STAFF REPORT

Case Number: 2023-UV1-013
Address: 5320 West Vermont Street (approximate address)
Location: Wayne Township, Council District #15
Zoning: C-4
Petitioner: Josh Investment Inc., by Pat Rooney
Request: Variance of use and development standards of the Consolidated Zoning and Subdivision Ordinance to provide for the construction of a 42-unit multi-family dwelling project (not permitted) with a 17-foot east transitional yard and 16-foot south transitional yard (20-foot transitional yards required), 29 parking spaces (31 required for multi-family), and deficient landscaping and lighting elements (landscaping and photometric standards required).

2023-UV1-013; Landscape Plan

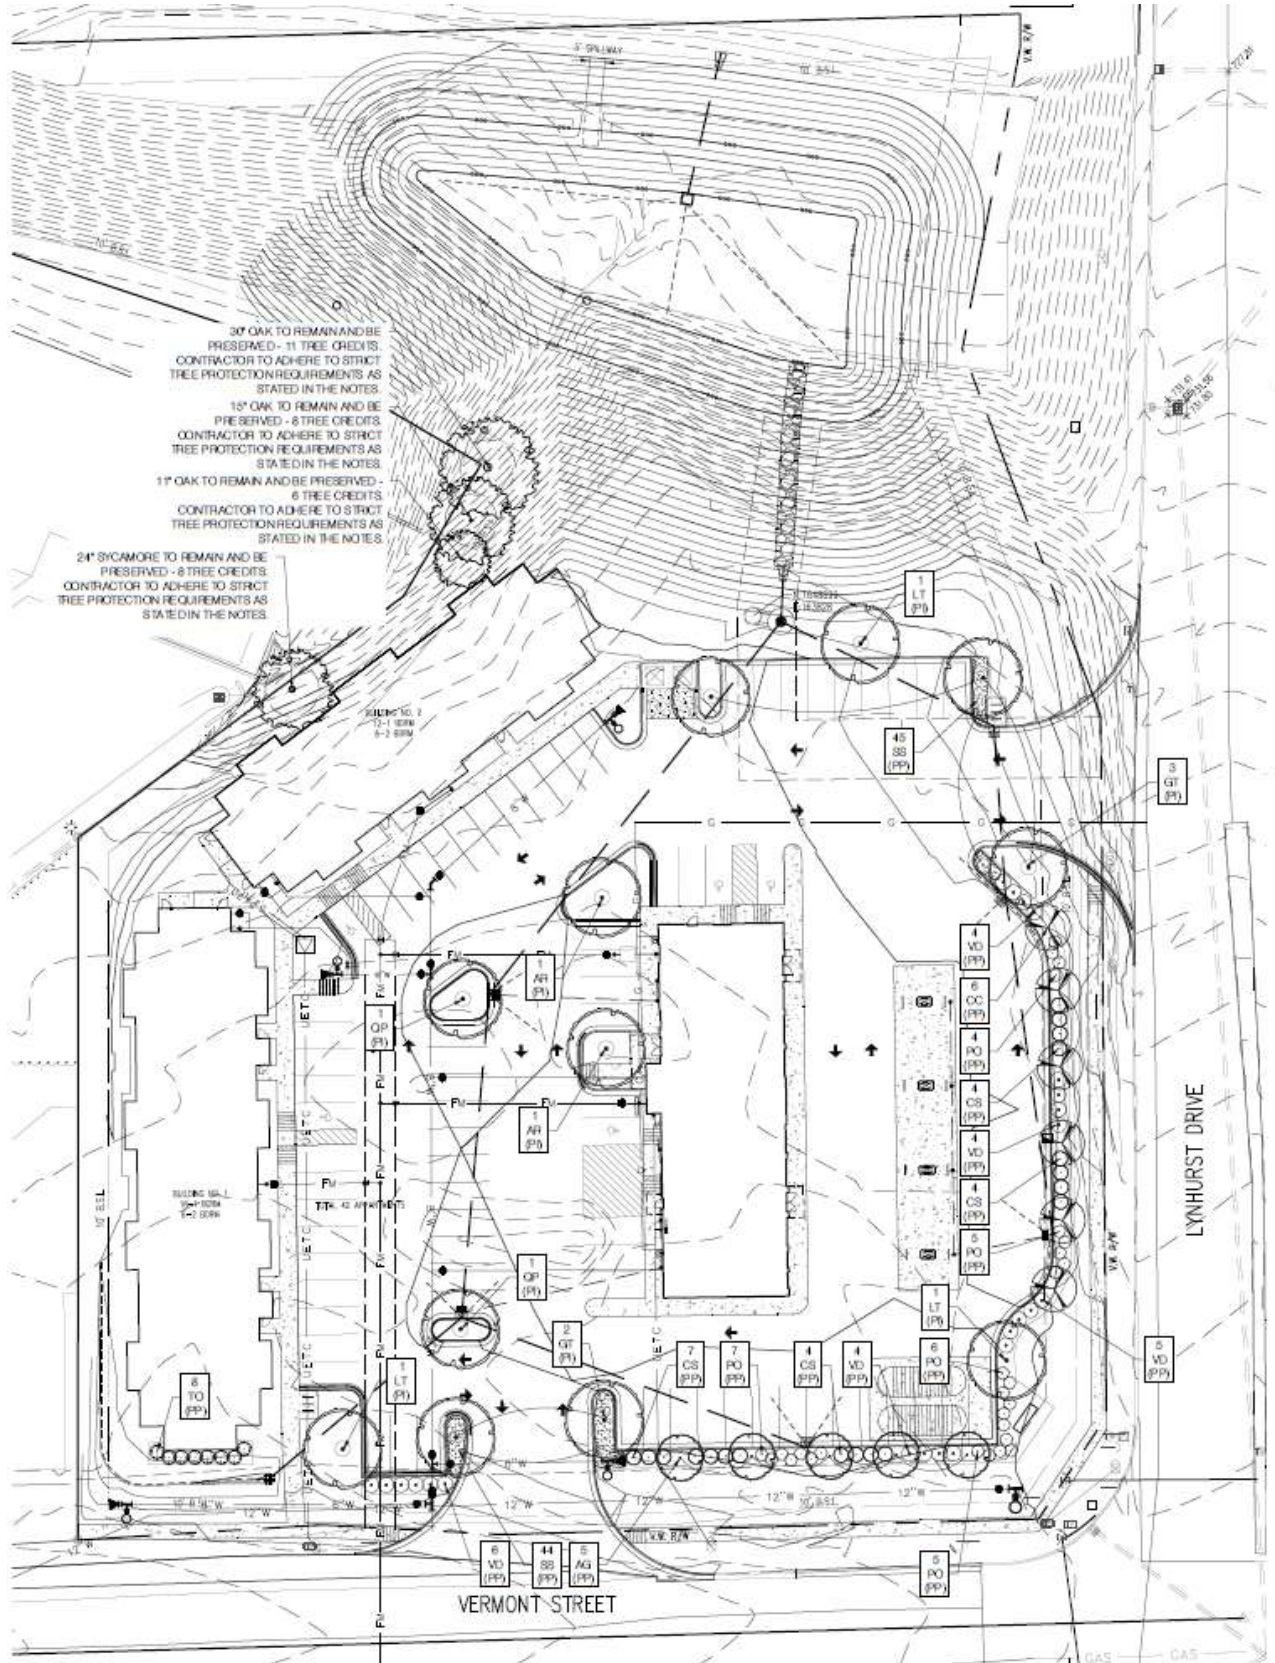
- ◇ The grant of the request would permit the development of the site to have deficient transitional yards, parking, landscaping, and lighting.
- ◇ The C-4 district in the Metro Context area requires 20-foot front transitional yards. As proposed, the site would have a 17-foot east transitional yard and a 16-foot south transitional yard.

- ◇ With this being all new construction, there is no reason why the 20-foot transitional yards could not be met to protect the religious and residential uses to the east and south from the more intense commercial use proposed.

2023-UV1-013; Photometric Plan

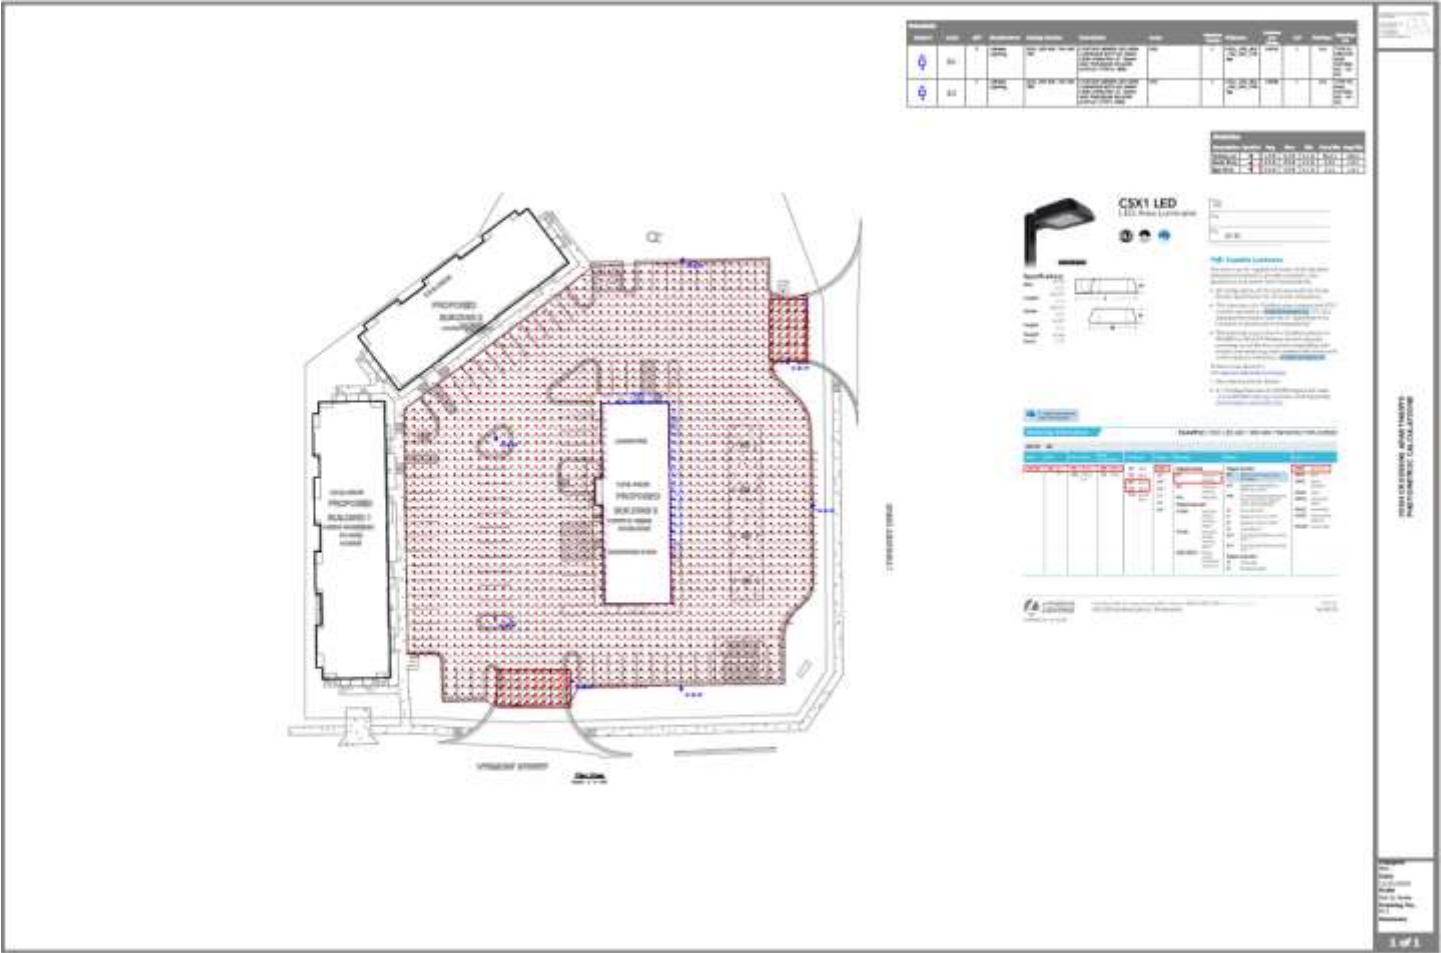
- ◇ The photometric plan provided did not extend to the entirety of the site as required by Table 744-604-1 for the entrances, walkways, and right-of-way. Additionally, the required light level standards were not met in the plan that was provided.
- ◇ Based on the landscape information provided, the required landscaping would not be met since the calculations of the required trees or plantings were not rounded up to the next whole number per Sec. 740-306.A. Staff was unable to confirm if the Green Factor would be met since a Green Factor calculation sheet was not provided.
- ◇ Ultimately, staff determined that the development standards could be met with the reconfiguration of the proposed development and strongly recommends that the request be denied.
